# DER Technical Forum

## Energy Networks Association

22 November 2018

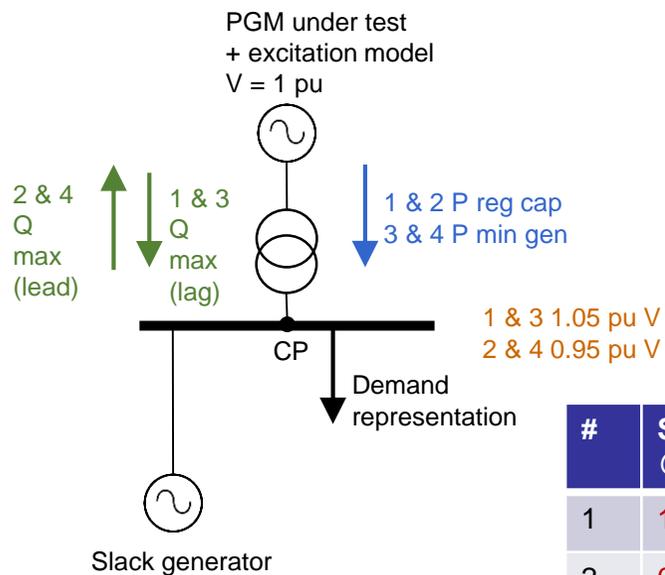
Q How should Reactive Capability be simulated? Is it practical for Type C / D studies to be based on a 1.0pu voltage on the generator terminals and 1.05 and 0.95 pu voltage at the Connection Point and 0.95 lag and lead power factors? Should the source impedance be modelled etc.?

A Please see following slide which illustrated this study. This is a theoretical study to demonstrate that the required VAR performance of the PGM is achievable at the connection point (the DNO can agree to this being demonstrated at the PGM rather than the connection point). For a Type C or D generator the likely presence of some impedance (eg a generator transformer) means the voltage at the PGM can be set at 1pu (generator set in PV mode) and then the VARs will adjust to meet the higher or lower V at the CP. If there is little or no impedance between the connection point and the generator then the generator should still be set in PV mode, but the resulting voltage at the generator may not be 1pu.

Note Annex C.7.3.3 details the need for possible additional demonstration requirements for PPMs
